**1st Phase Park Improvements Project - Cabana Park
Project 2019-2-CA**

Pre-Bid Walk Questions - Addendum #1 Page 1 of 5

Area of 90% compaction

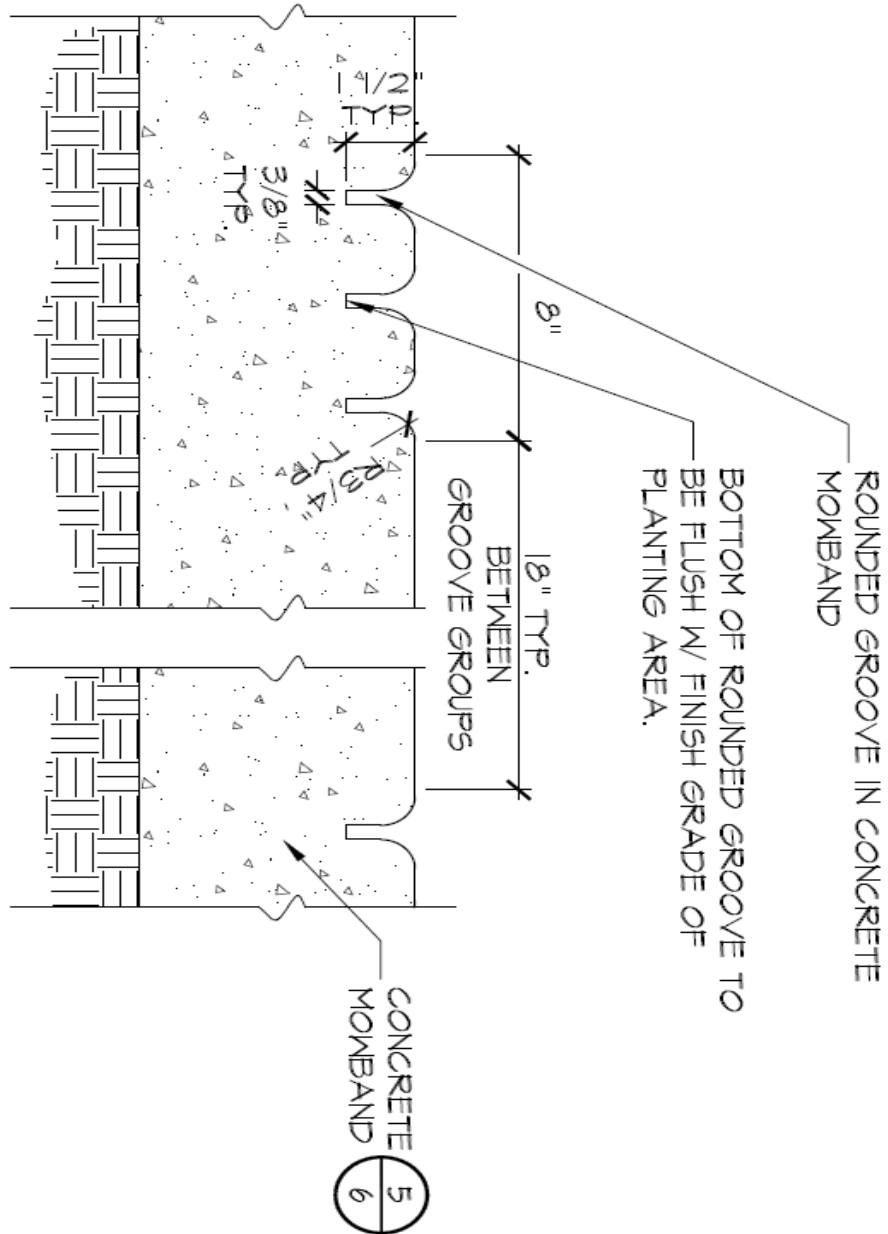
See page 4 of 5 for the overlay of the old pools and the paving areas to see where over-excavation may be needed and compacted to achieve 90% sub-base compaction.

Contractor should plan on over-excavating 24" in these two areas and bring up in lifts to achieve 90% compaction.
